DESERT TORTOISE COUNCIL

RE: Formal comments on the proposed Silurian Valley Solar Project

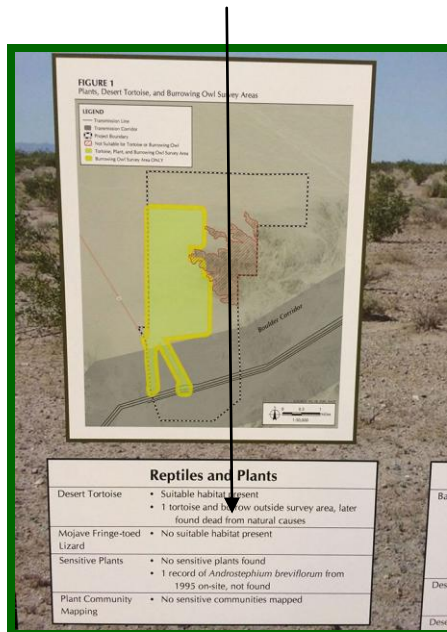
6. We note on Figure 1 (see below) that “1 tortoise and burrow [were found] outside survey area, later found dead from natural causes,” which was the only reported tortoise sign found during protocol surveys in 2013.

During the break when I spoke with Dr. Pauline Roberts of Sapphos, I was alarmed and felt misled when she indicated that, in fact, five tortoise burrows had actually been found **on the site**. There are several red flags associated with this revelation. First, if tortoise sign had been found onsite, why did Figure 1 divulge that only the one animal had been found in adjacent areas? It would certainly have been more appropriate and less misleading, to indicate on the figure that five burrows were found onsite, without necessarily revealing their exact locations, to protect tortoises.

Given that the biological report cannot be made public, we'd like to ask the BLM the following questions: Is this site considered occupied habitat, as the presence of five tortoise burrows would indicate? Or, are only adjacent areas occupied, as implied by Figure 1 that shows a single animal (now dead) was observed in adjacent areas only? Since the results of this 2013 survey remain valid for only one year per USFWS survey protocol and are therefore already outdated, the site must be surveyed again prior to development. As such, we strongly encourage the BLM to review the experience levels of future surveyors to ensure they have the ability to identify and differentiate tortoise sign from sign of other animals.

7. We also question the consultant's conclusion that the red-highlighted area in Figure 1 is not suitable for either tortoises or burrowing owls. Was this area deemed unsuitable as a result of surveys? Or, as it would appear, did the biologists not survey it because it appeared unsuitable? We note in Figure 1 that the red-highlighted area is outside the survey area for tortoises and burrowing owls, so how can the presence of these two species be dismissed in the absence of protocol surveys? In April 2014, I surveyed a similarly mountainous area south of Barstow that was occupied by both tortoises and burrowing owls (which were using tortoise burrows, kit fox dens, and badger digs in very rocky areas). Given its proximity to the proposed development and likelihood of supporting both tortoises and burrowing owls, the BLM (if this project is to proceed) must ensure that the red-highlighted area is actually surveyed to substantiate the consultant's apparently site-unseen conclusion.
